Responses to TD's Comments

**Review on Feasibility of Run-in/out and Internal
Transport Provision**

**Annex A
Drawing A1
Review on Feasibility of Run-in/out and Internal
Transport Provision**

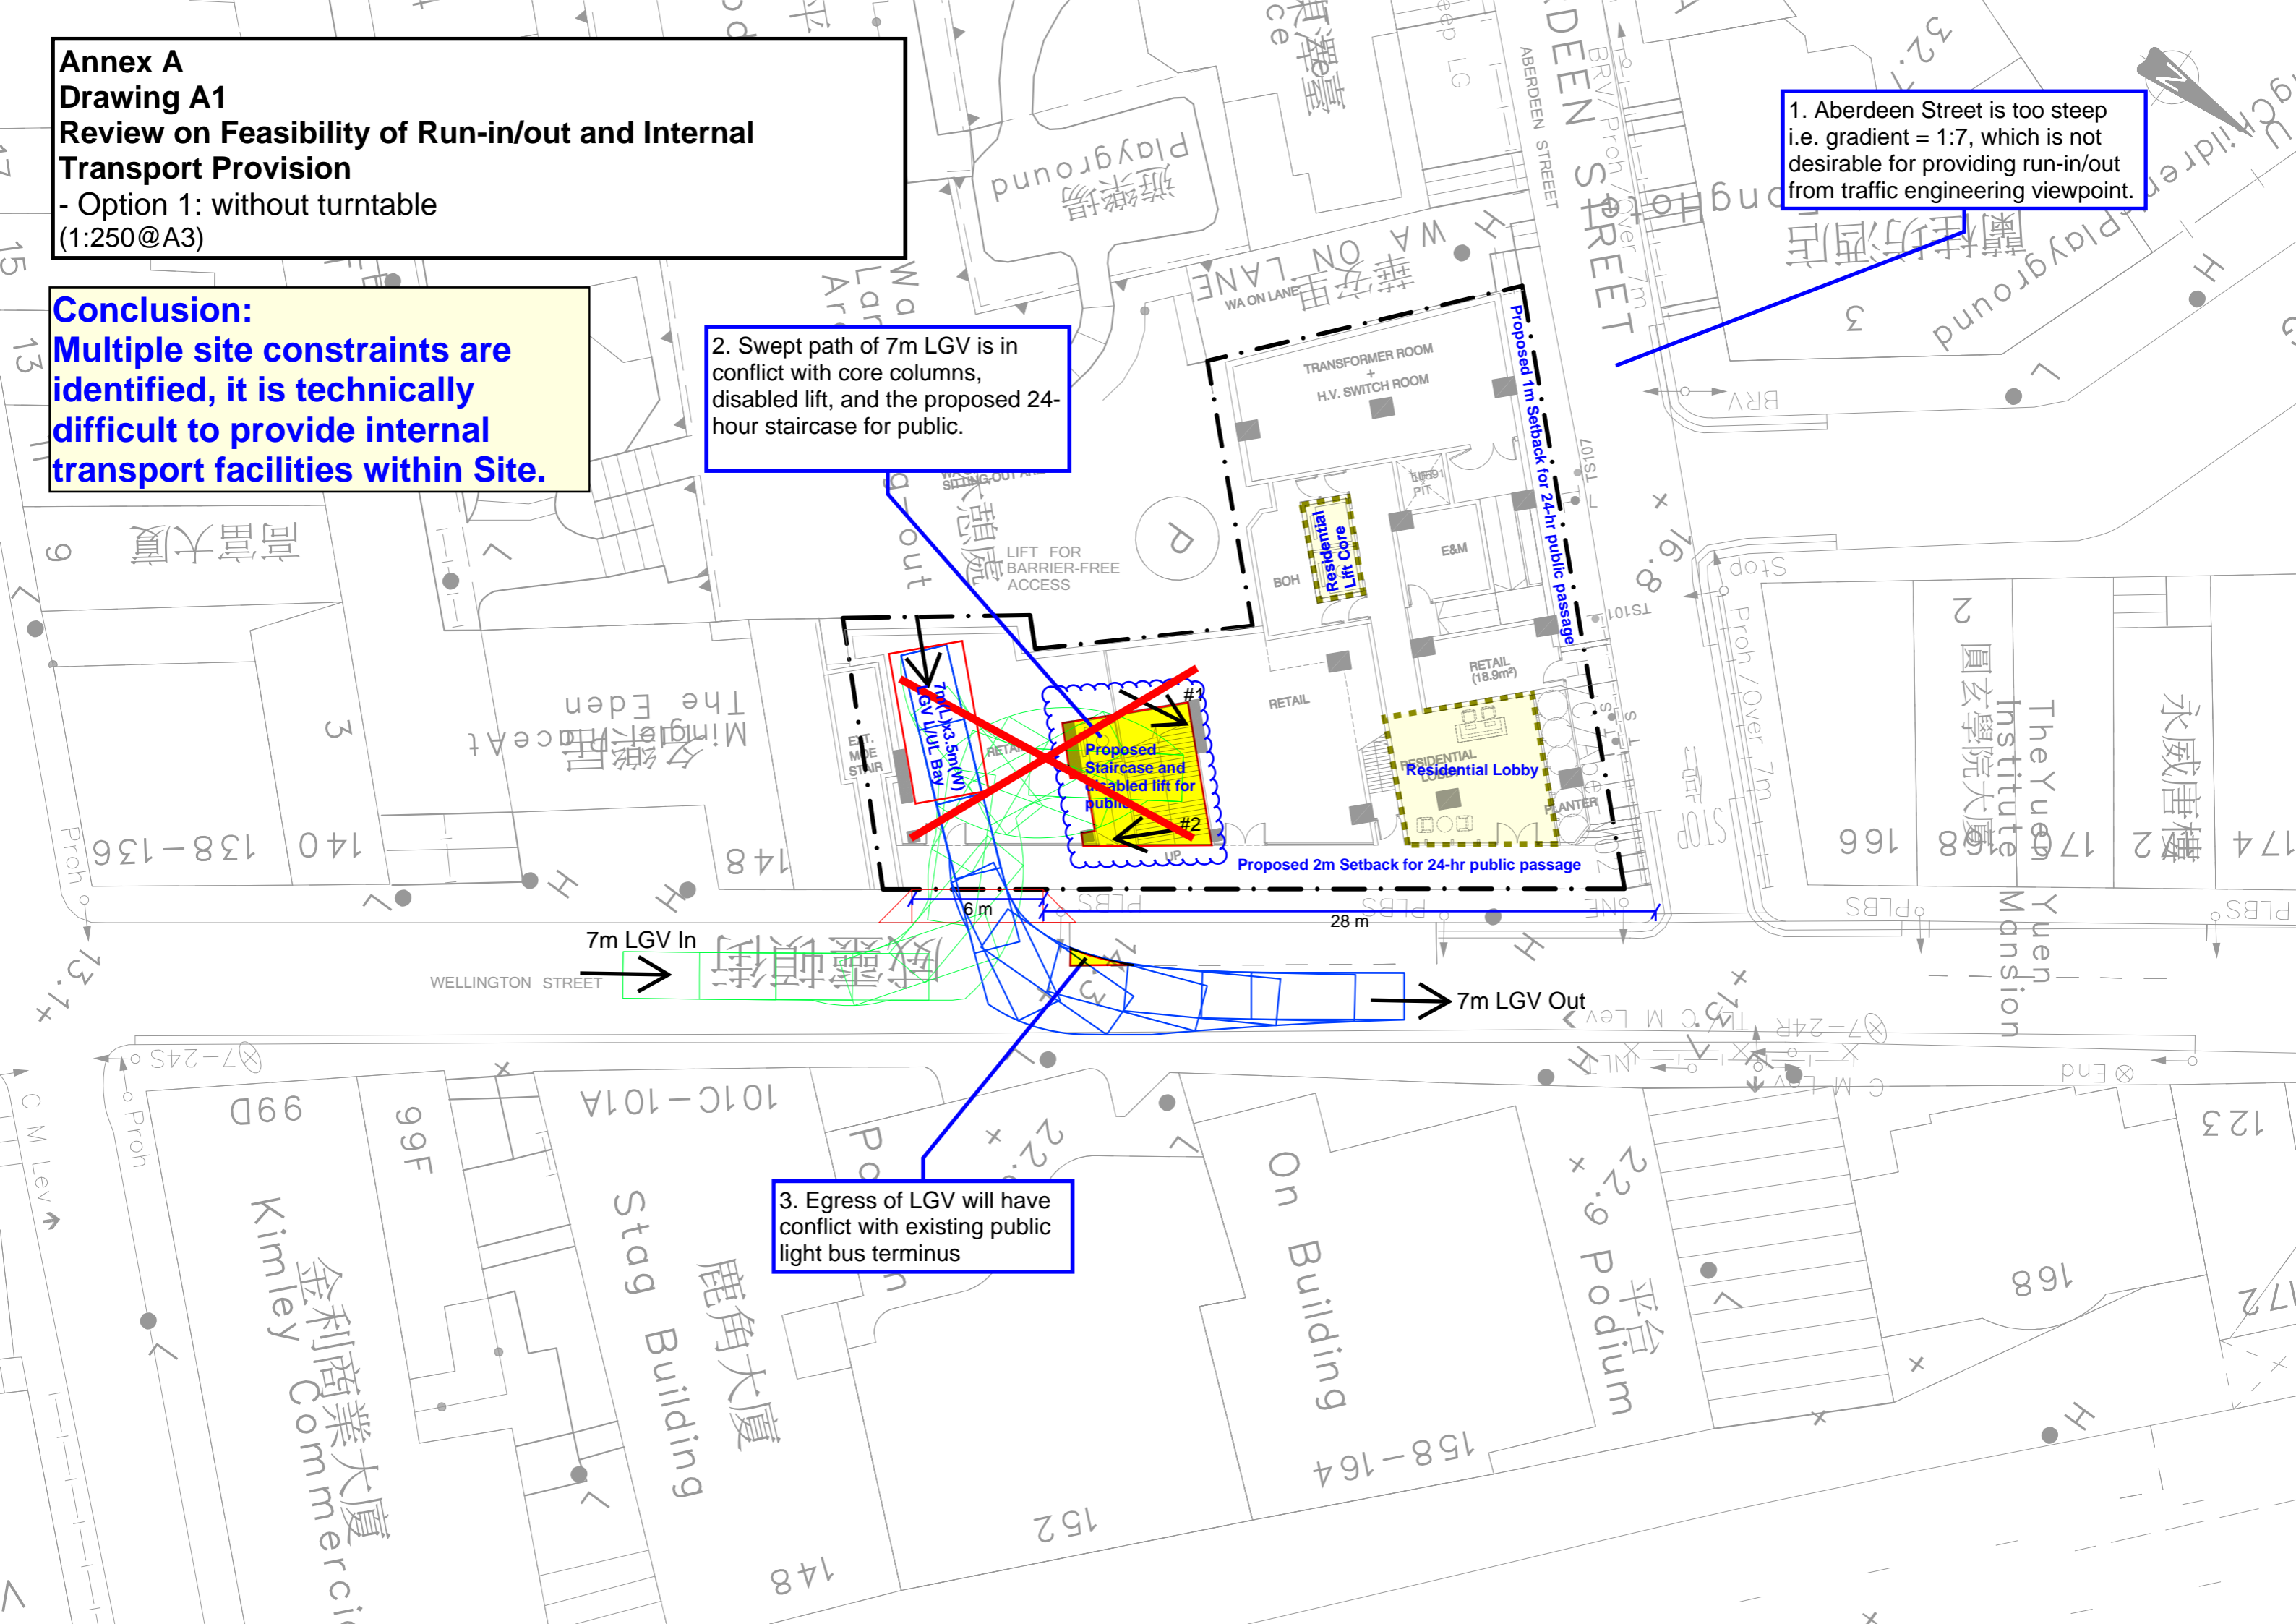
Conclusion:
Multiple site constraints are identified, it is technically difficult to provide internal transport facilities within Site.

1. Aberdeen Street is too steep i.e. gradient = 1:7, which is not desirable for providing run-in/out from traffic engineering viewpoint.

2. Swept path of 7m LGV is in conflict with core columns, disabled lift, and the proposed 24-hour staircase for public.

3. Egress of LGV will have conflict with existing public light bus terminus

Annex A
Drawing A2
Review on Feasibility of Run-in/out and Internal Transport Provision
 - Option 2 : without turntable
 (1:250@A3)

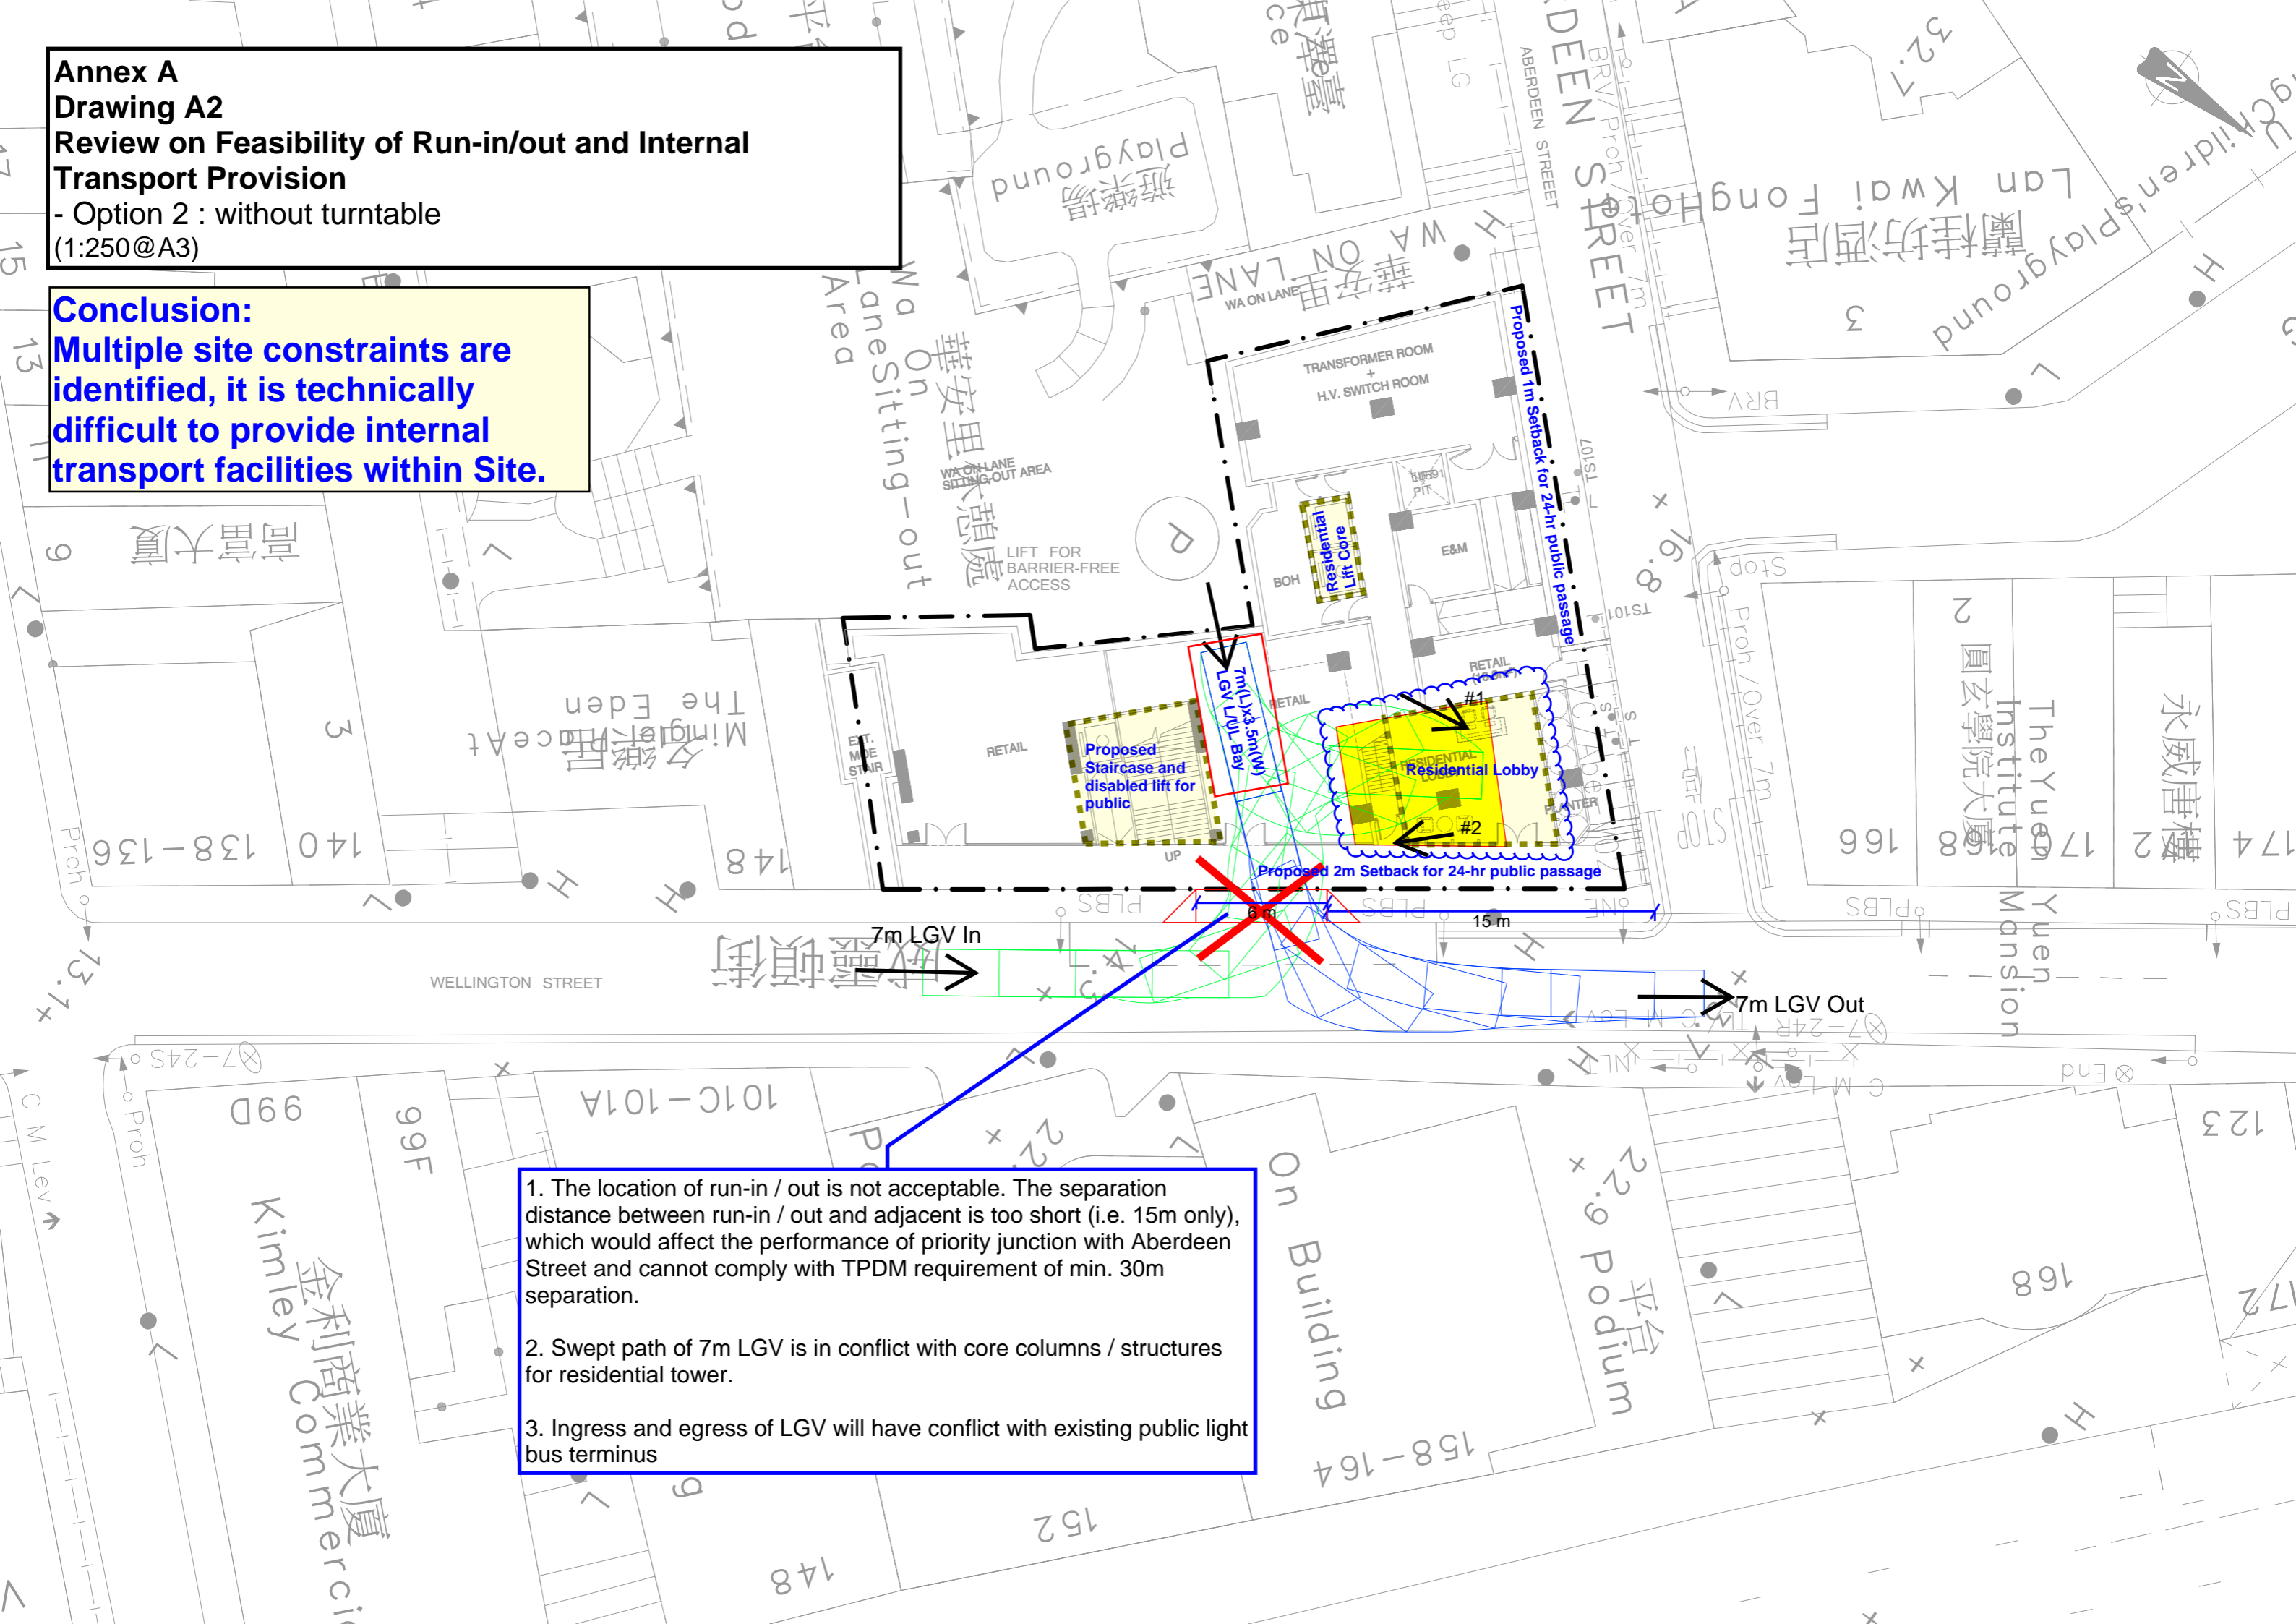
Conclusion:
 Multiple site constraints are identified, it is technically difficult to provide internal transport facilities within Site.

1. The location of run-in / out is not acceptable. The separation distance between run-in / out and adjacent is too short (i.e. 15m only), which would affect the performance of priority junction with Aberdeen Street and cannot comply with TPDM requirement of min. 30m separation.
2. Swept path of 7m LGV is in conflict with core columns / structures for residential tower.
3. Ingress and egress of LGV will have conflict with existing public light bus terminus

Annex A
Drawing A3
Review on Feasibility of Run-in/out and Internal Transport Provision
 - Option 3 : with turntable
 (1:250@A3)

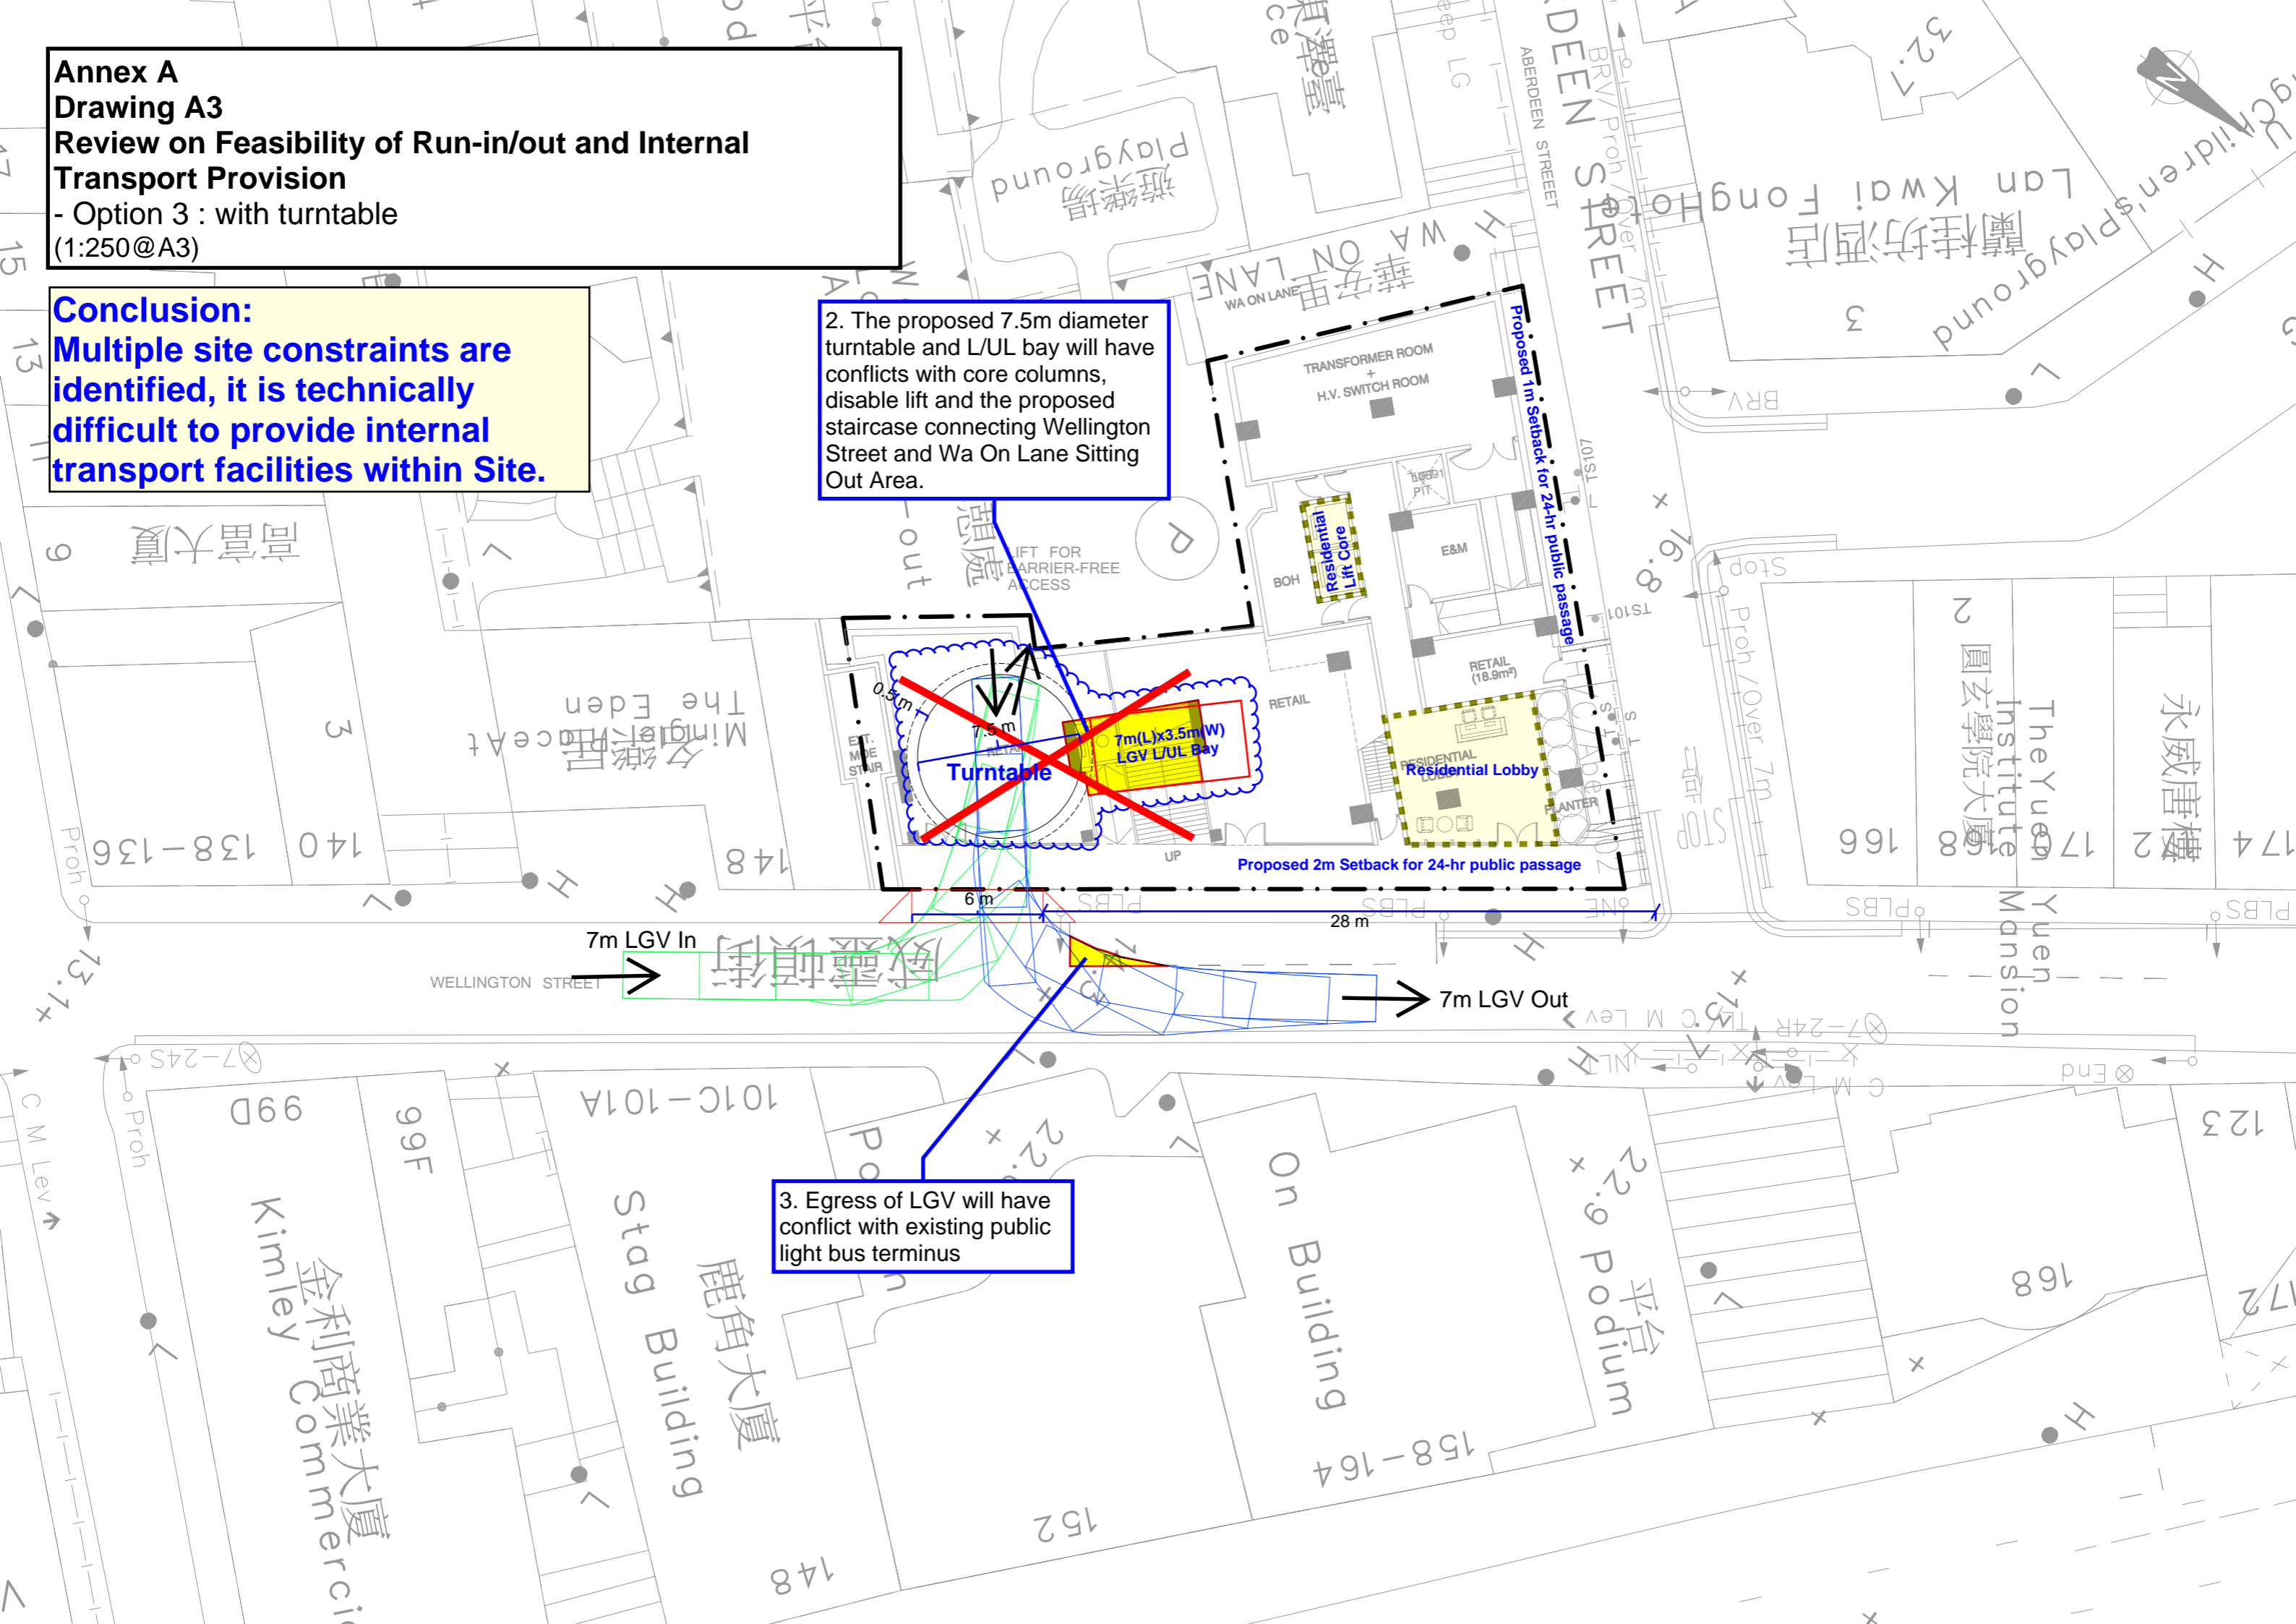
Conclusion:
 Multiple site constraints are identified, it is technically difficult to provide internal transport facilities within Site.

2. The proposed 7.5m diameter turntable and L/UL bay will have conflicts with core columns, disable lift and the proposed staircase connecting Wellington Street and Wa On Lane Sitting Out Area.

3. Egress of LGV will have conflict with existing public light bus terminus
